**BEFORE THE PUBLIC UTILITY COMMISSION  
OF OREGON  
PCN-2**

**INTERVENOR TESTIMONY OF DAVID MAST**

# David Mast – Intervenor Testimony - Issues List

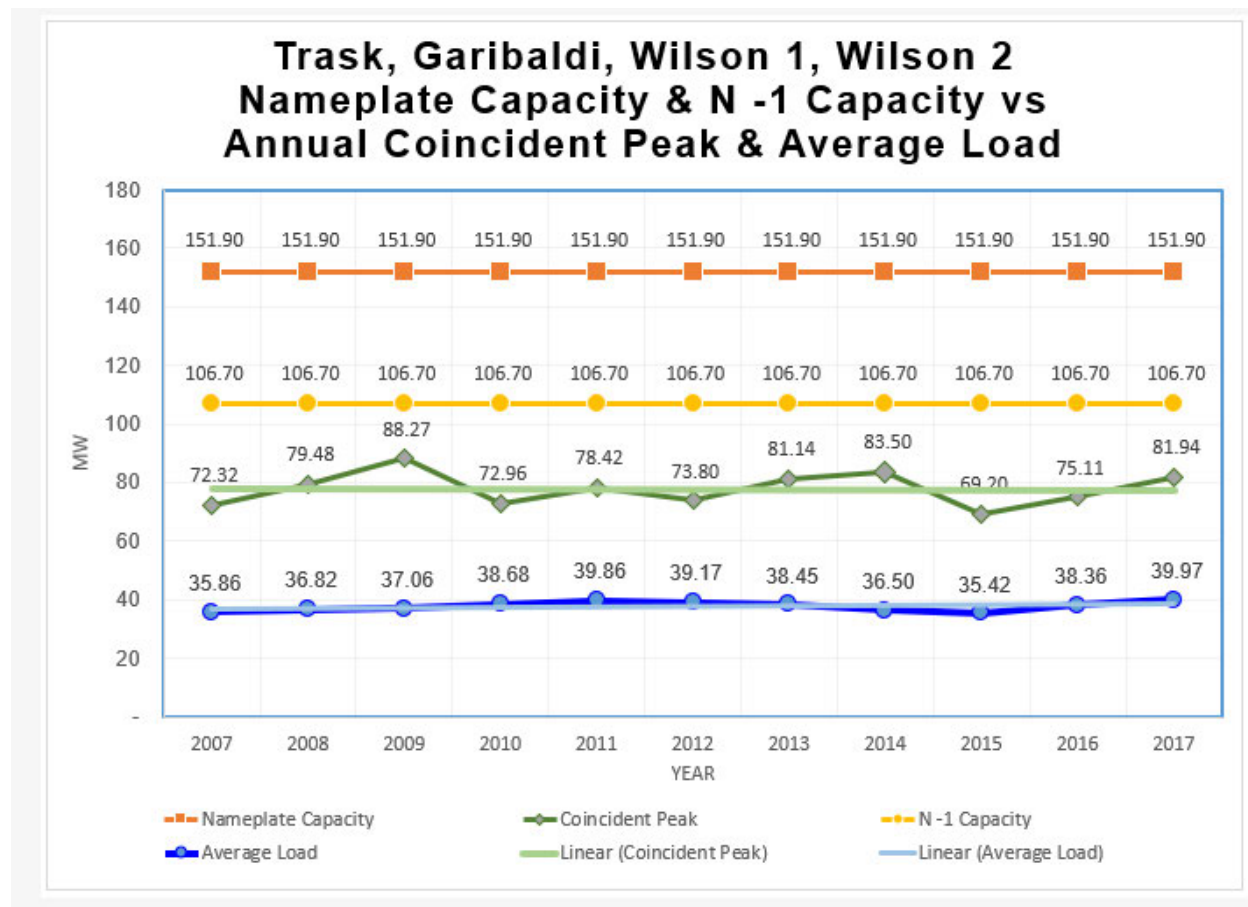
Garibaldi substation loads for every hour of every day. I summarized the data from the TPUD Exhibit and developed the chart shown below.

The total capacity of the 4 substations that feed the central valley and Oceanside – Netarts is 151.9 MW. The N -1 capacity is 106.7 MW. The maximum peak which occurred in 2009 was only 58% of the capacity of the 4 substations and only 83% of the substations’ N -1 capacity. The average load on the substations was 37.83 MW. That is only 24.9% of the substations’ total capacity and only 35.4% of their N -1 capacity.

From the data, I see that TPUD is able to adequately provide service to existing and new loads without needing to build a transmission and substation to Oceanside – Netarts.

KC Fagen's Chart – Wilson 1 & 2 Growth

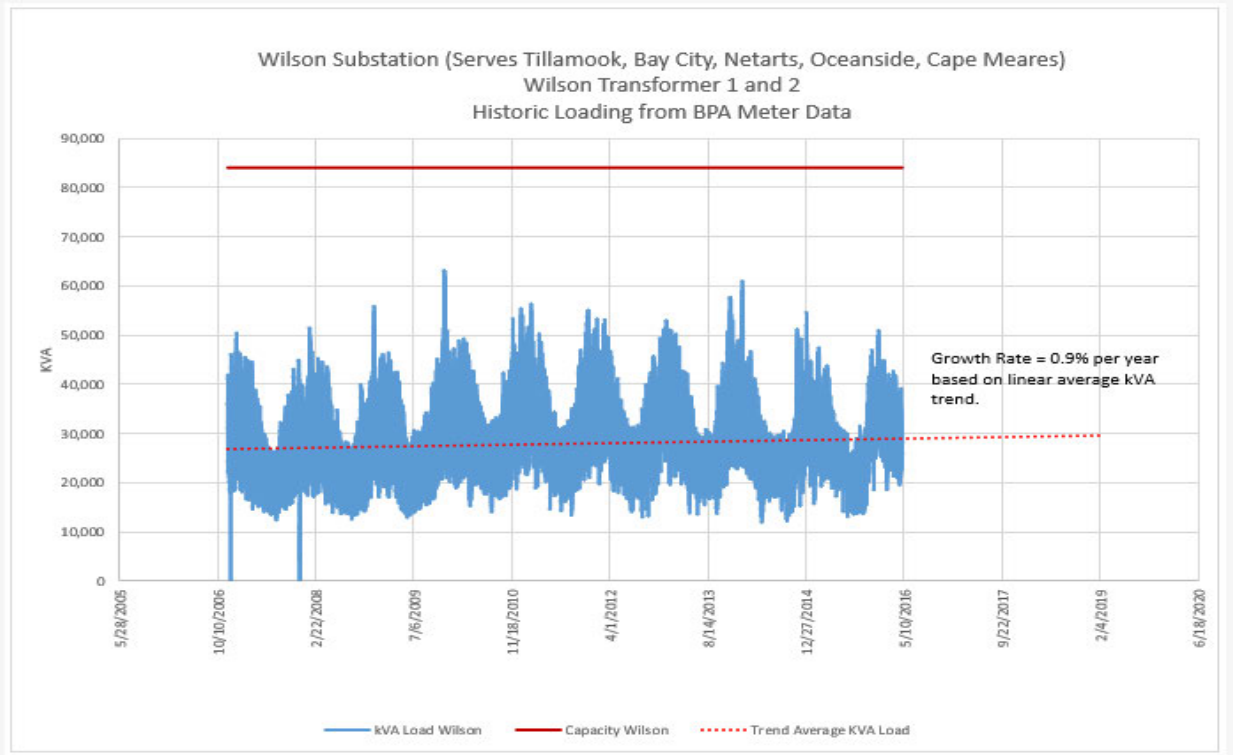
In his follow up testimony, KC Fagen reports a growth of 0.9259% per year for Wilson 1 & 2<sup>6</sup>. KC Fagen's 0.9259% growth for Wilson T1 & T2 is based on the load trends of the Wilson River 1 & 2 from 2006 – 2016. His analysis has the same major error and is also significantly distorted upward because it also ignores the fact that in 2009 the TCCA boiler came on line. His chart gives a false assumption about the future growth of Wilson River 1 & 2.

I took TPUD's data that KC Fagen used for his trend line and developed a trend line from 2009 – 2016 to eliminate the load distortion that occurred when the boiler came on line in 2009. The trend line for 2009 – 2016 based on TPUD's data shows that growth on Wilson River 1 & 2 was flat, showing that all the growth KC Fagen is talking about, in fact, came from the TCCA boiler going on line. (Data is from Staff DR 19 a b c e)

Same TPUD data as KC Fagen's just charted from 2009 - 2016

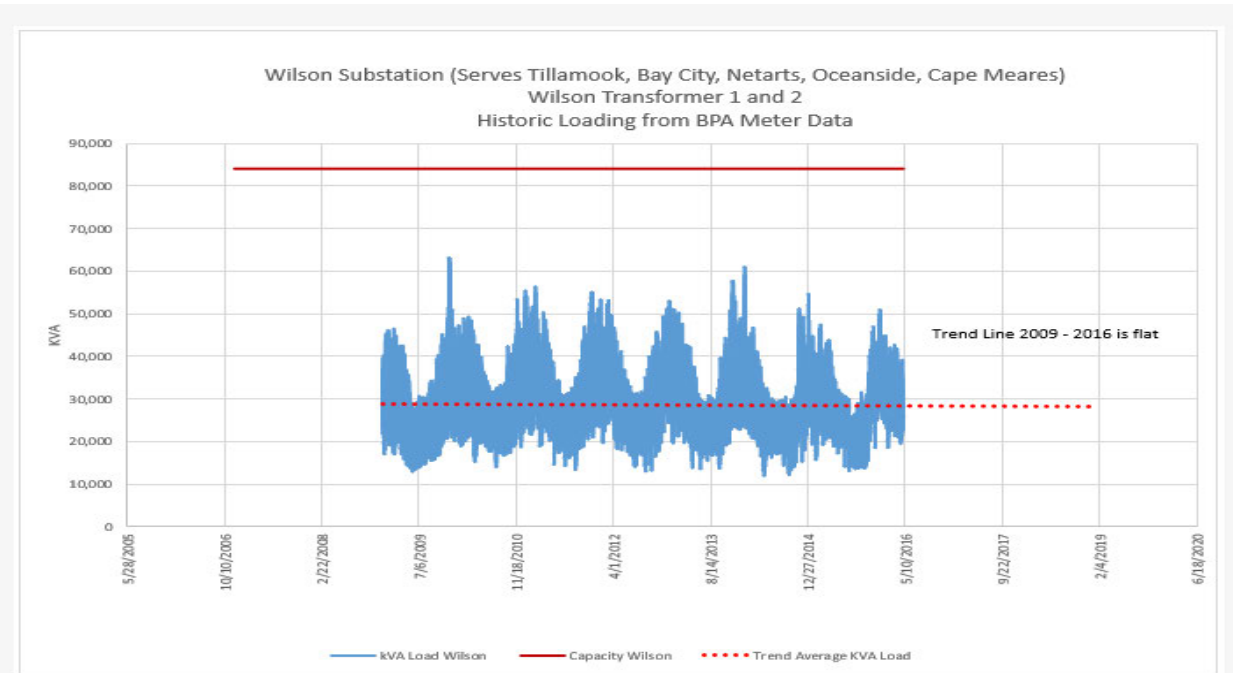
KC Fagen’s 0.9259% load growth number is a significantly distorted number. The 2012 official forecast was for a total system growth of 0.45%. Actual growth from 2012 – 2017 in the total system was below 0.45%. Growth of the 4 substations that serve the central valley is only 0.20%. Wilson T1 & T2 show no growth in 2009 – 2016. The projected growth in the 2019 Budget is only 0.5%<sup>7</sup>. Nowhere do any of the growth numbers come close to the 0.9259% he is using to justify the need for the transmission line and substation.

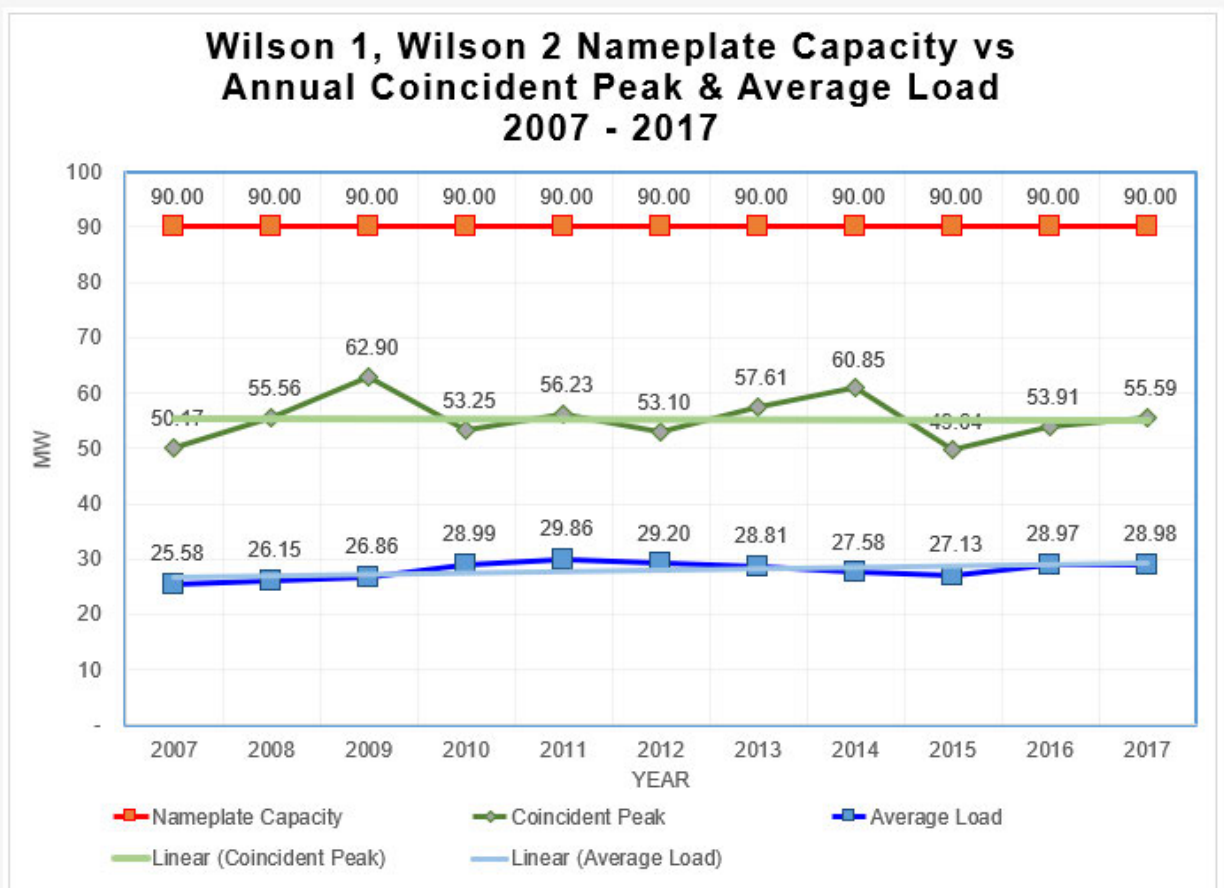
Below, I have graphed the average loads and coincident peaks for Wilson 1 & 2. This data is also from TPUD Exhibit 403 W1-W2 load. Notice the growth in the average load between 2008 and 2009 because of the addition of the TCCA boiler. You can see that the maximum load Wilson 1 & 2 is only 70% of capacity and average load is only 33% of capacity.

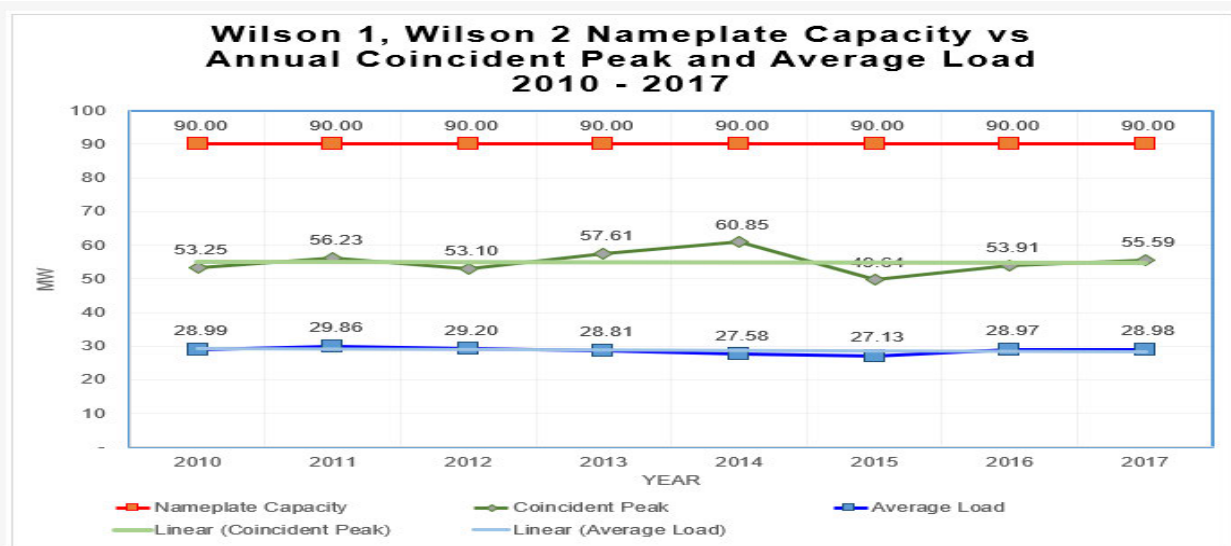
Below, I have graphed the average loads and coincident peaks for Wilson 1 & 2 starting in 2010 after the 4 MW TCCA electric boiler went on line. You can see that the coincident peaks and average loads of the Wilson 1 & 2 after 2009 are flat.

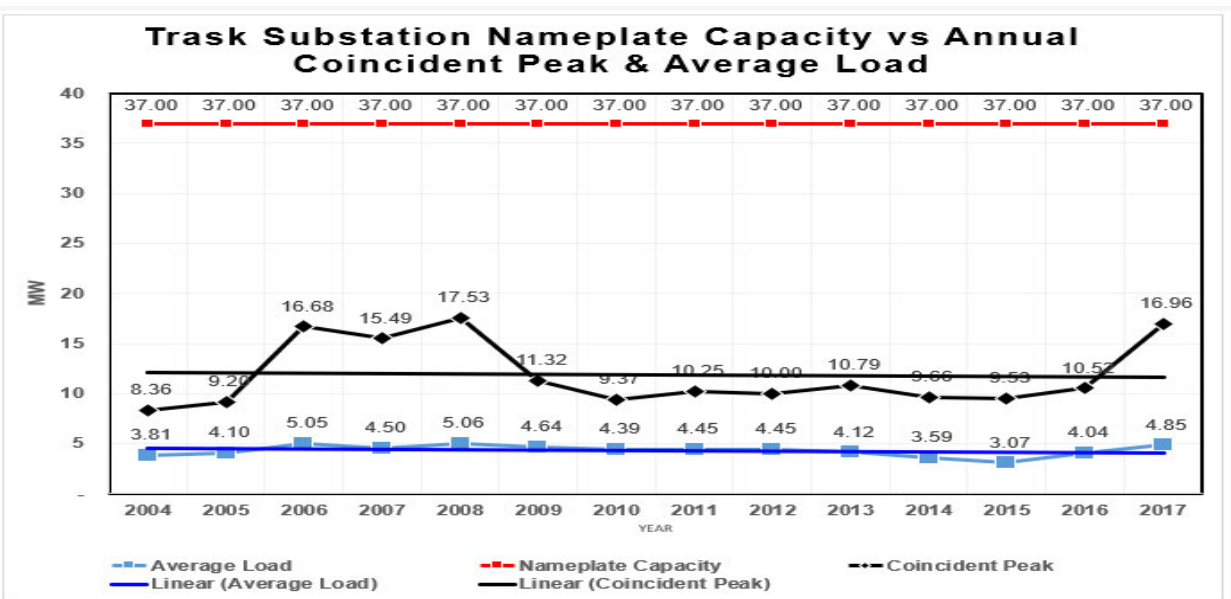
The Trask substation is only loaded at 12% of capacity and the highest coincident peak was only 47% of capacity. Moving feeder 51 to the Trask would relieve 5 – 12 MW from the Wilson River T1 & T2 and it would put the Task at a more efficient level. The \$16 transmission line/substation is planned to take load off the Wilson Rivers. Moving feeder 51 to the Trask accomplishes the same thing for a lot less cost.
